CITY OF DE PERE

ADDENDUM NO. 1
PROJECT 22-11
2022 UTILITY AND STREET CONSTRUCTION WATERVIEW HEIGHTS FIFTH ADDITION

CHANGES TO PROJECT BID DOCUMENTS:

CHANGES TO PLANS:

BID SET
 SHEET NO.
13R

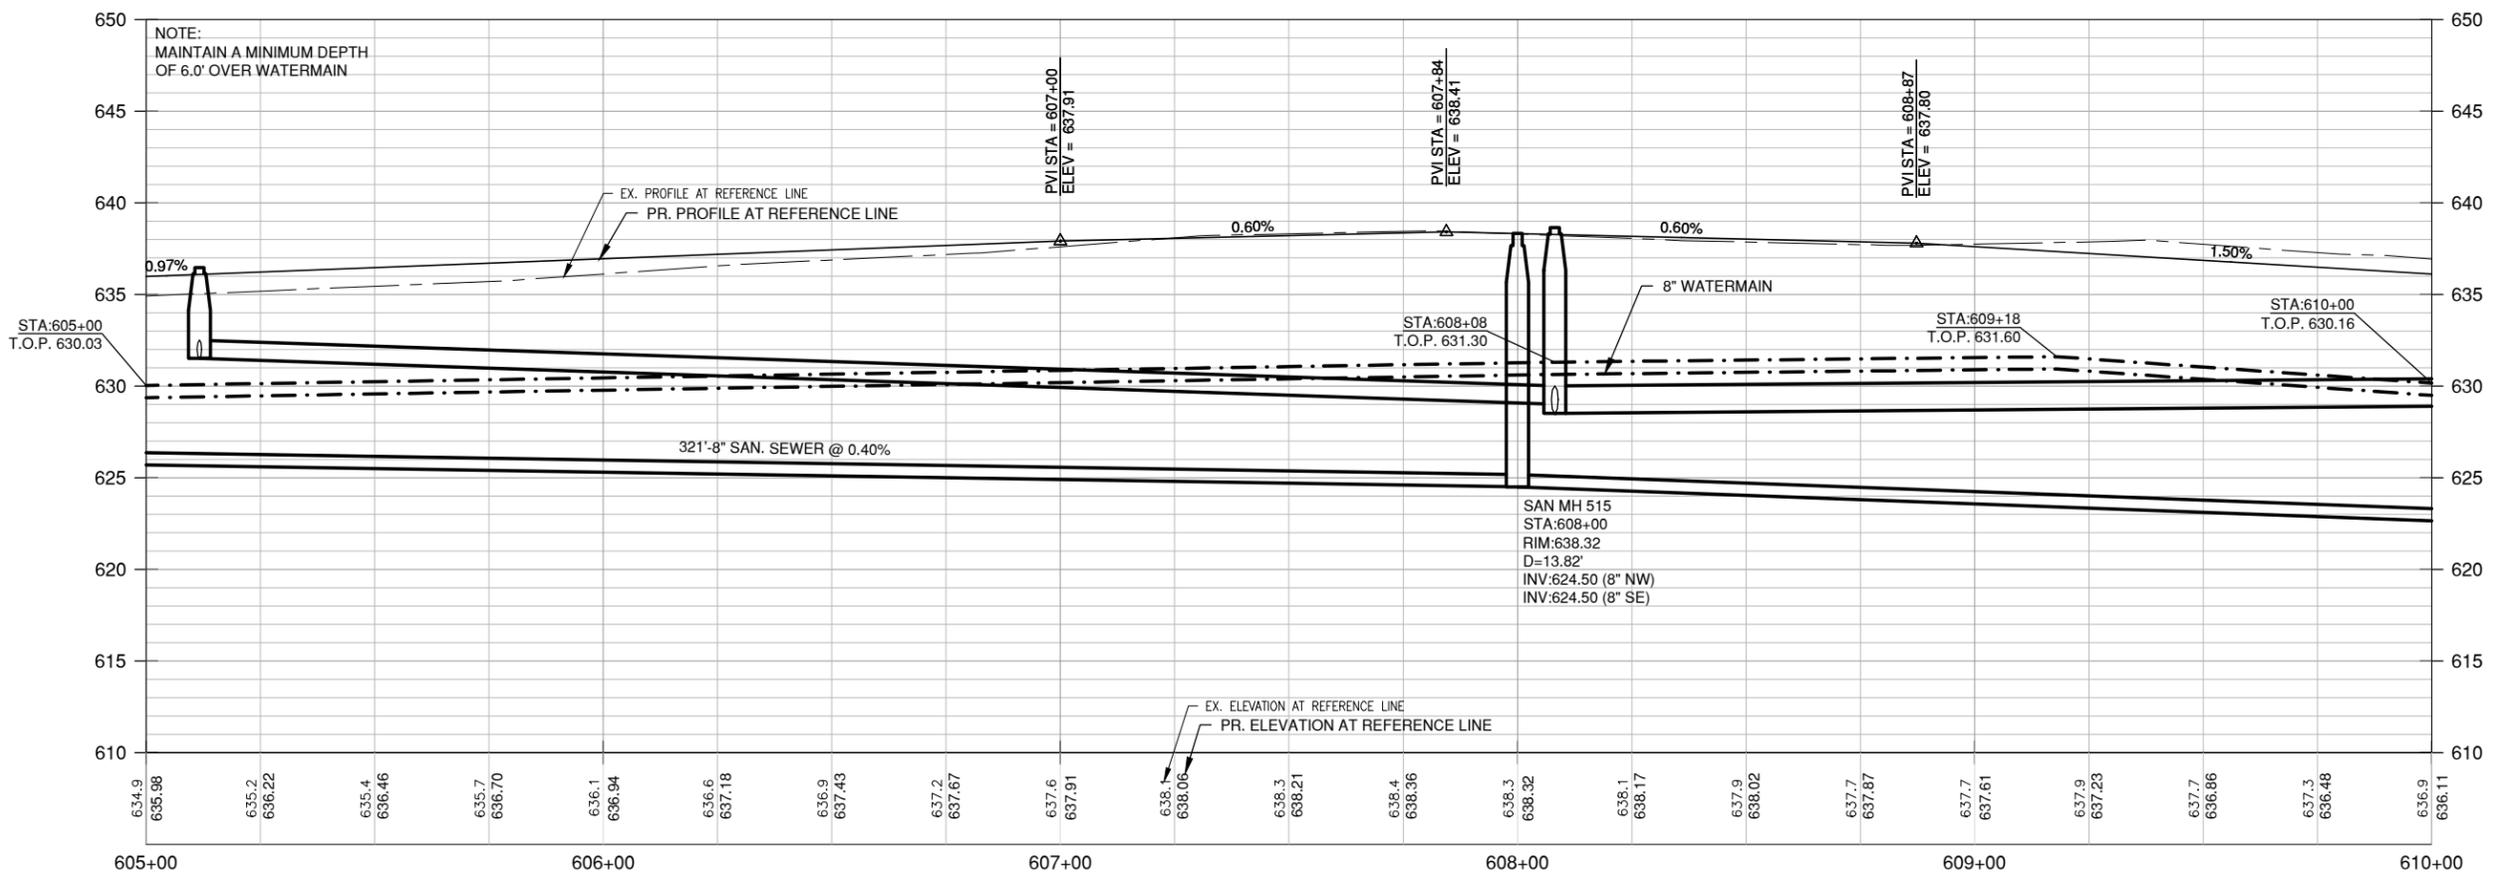
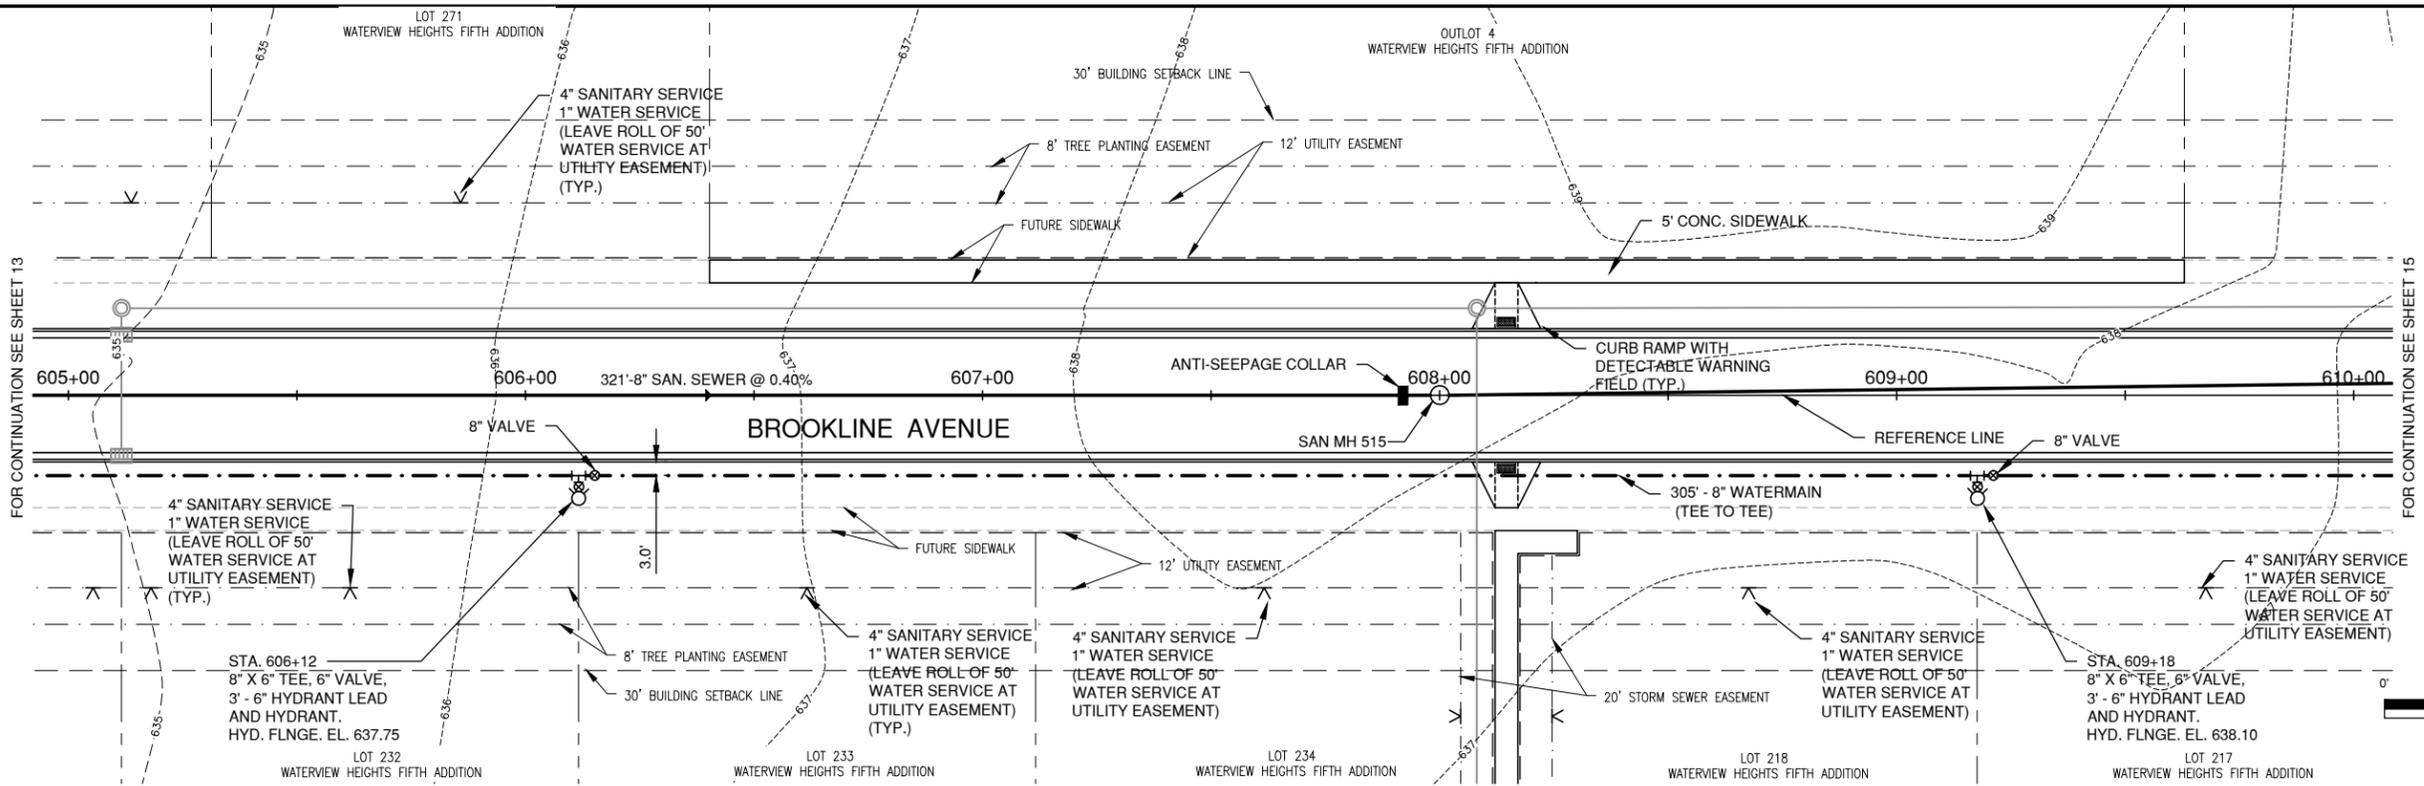
NO.	DATE	APPROV.	REVISION	NO.	DATE	APPROV.	REVISION
1	5/22/2022	BDR	PROFILE DATA SHOWS UP

BID SET
 SHEET NO.
14R

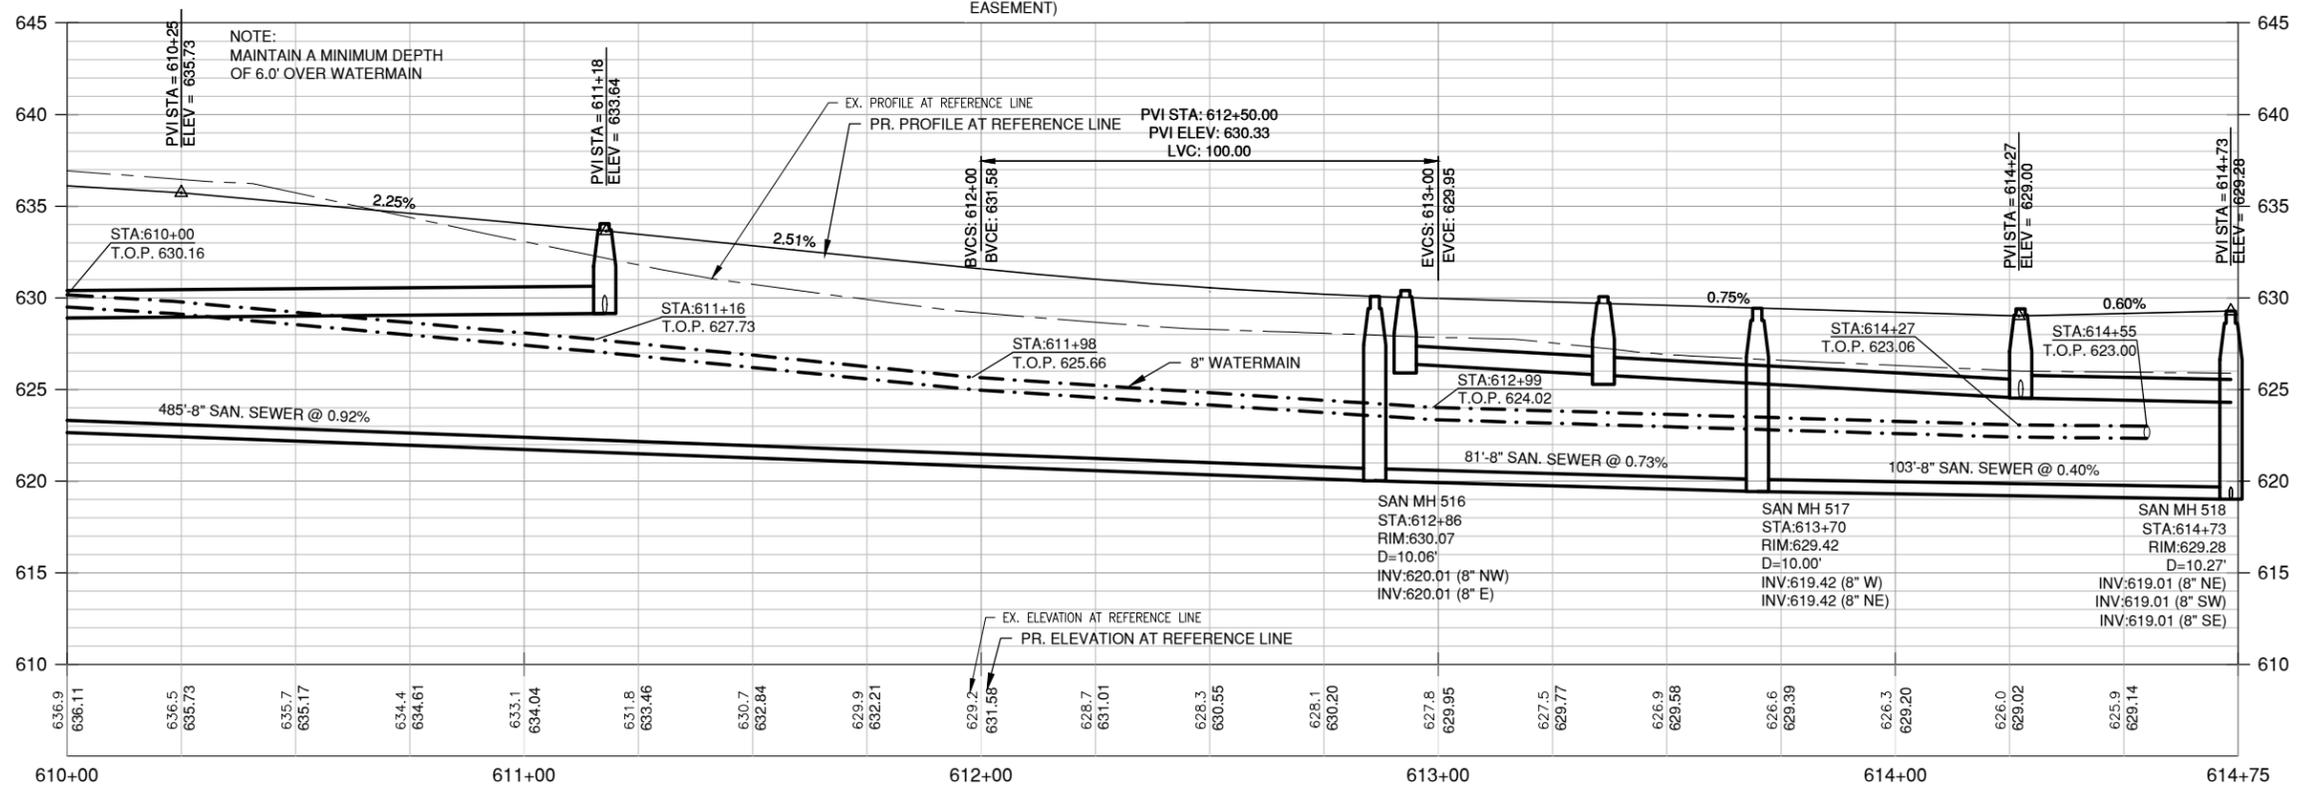
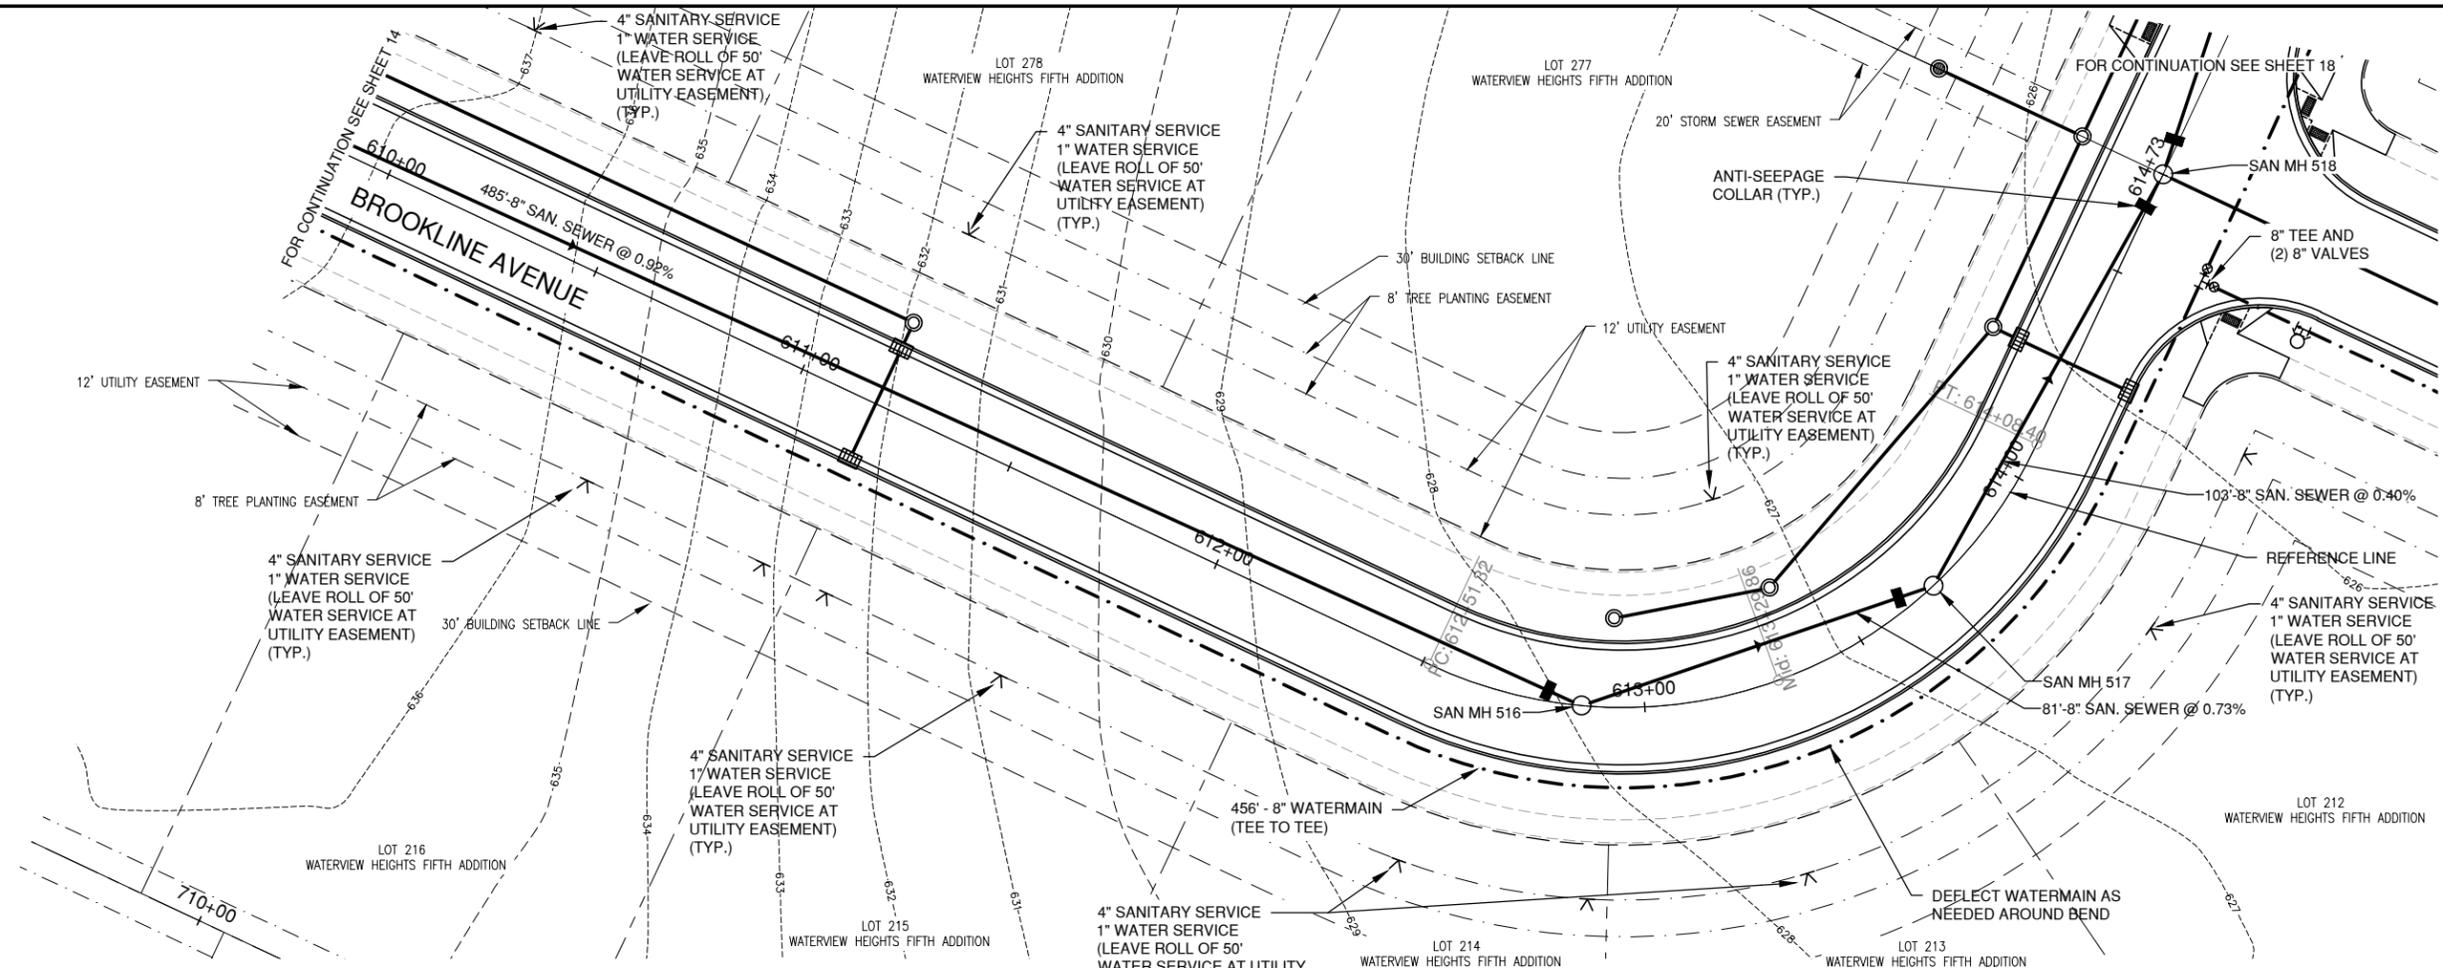
NO.	DATE	APPROV.	REVISION	NO.	DATE	APPROV.	REVISION
1	5/22/2022	BDR	PROFILE DATA SHOWS UP
